Access Compliance Report

Public Rights-of-Way

(Curb Ramps)

Intersection ID: 7422	Main Street: BOXMEER_DR	Cross Street: STATESVILLE_RD	Location: NE
ADA ID: 3D9BA8290B34	Ramp Type: Perp	Initial Pass/Fail: Fail	Overall Compliance: No
			Severity Score: 21.25

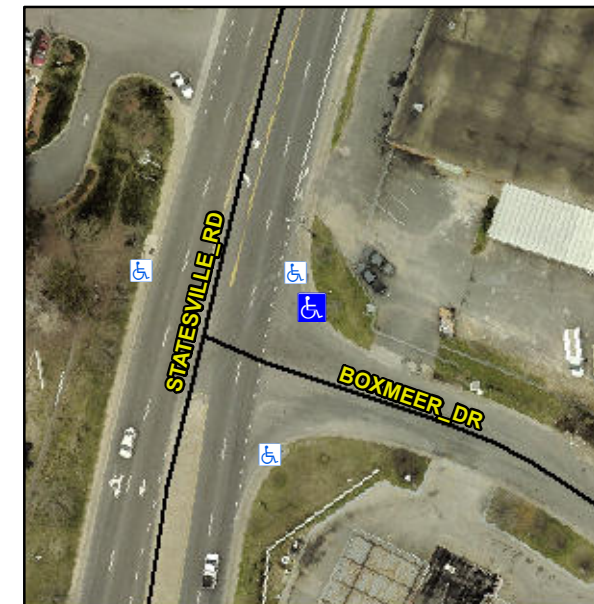
Not Found, R304.5.1, R304.2.2

Compliance	Description	Data	Compliance	Description	Data
N/A	Ramp Length (in)	62.0	No	Ramp Slope (%)	11.0
No	Ramp Width (in)	36.0	Yes	Ramp XSlope (%)	1.2
N/A	Flare Type LT	N/A	N/A	Flare Type RT	N/A
N/A	Flare Slope LT (%)	N/A	N/A	Flare Slope RT (%)	N/A
N/A	Flare Traversable LT?	N/A	N/A	Flare Traversable RT?	N/A
N/A	Landing Length (in)	N/A	N/A	DWS Provided?	N/A
N/A	Landing Width (in)	N/A	N/A	DWS Contrast?	N/A
N/A	Landing Slope (%)	N/A	N/A	DWS Length (in)	N/A
N/A	Landing X Slope (%)	N/A	N/A	DWS Full Width?	N/A
N/A	Landing Curb? (Y/N)	N/A	N/A	DWS Offset (in)	N/A
N/A	Shared Landing?	N/A			
N/A	Gutter Ponding?	N/A	N/A	Gutter Slope (%)	N/A
N/A	Gutter Lip Ht (in)	N/A	N/A	Gutter X Slope (%)	N/A
N/A	Painted X Walk1?	No	N/A	Painted X Walk2?	N/A
	X Walk 1 Direction	To SW		X Walk 2 Direction	N/A
N/A	X Walk 1 Width (in)	N/A	N/A	X Walk 2 Width (in)	N/A
	X Walk 1 Slope (%)	1.0		X Walk 2 Slope (%)	N/A
	X Walk 1 X Slope (%)	1.2		X Walk 2 X Slope (%)	N/A

Remove & Replace Entire Ramp.
